WILLOWS ENGINEERING

RE: Geotechnical Assessment and Forms for Proposed Development

45 Tatiara Crescent, North Narrabeen NSW 2101

Report No. 2223016-R1

Figure 1 – Extract from Fortey & Grant Architecture Drawing No. S445-11

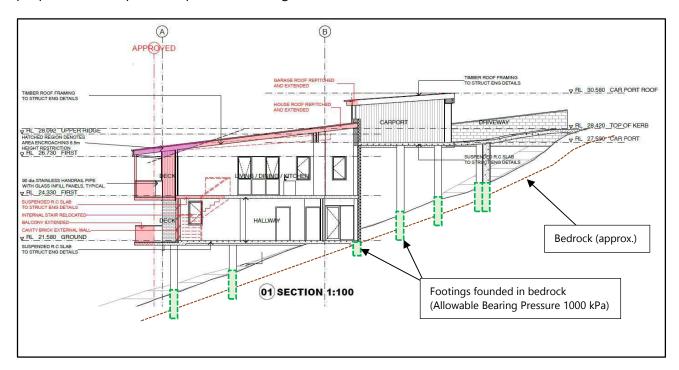
The approximate bedrock is annotated on the cross section. The footings for the proposed development are to be founded in bedrock, verified by geotechnical engineer to be suitable for the Allowable Bearing Pressure of 1000 kPa used in the structural engineering design.
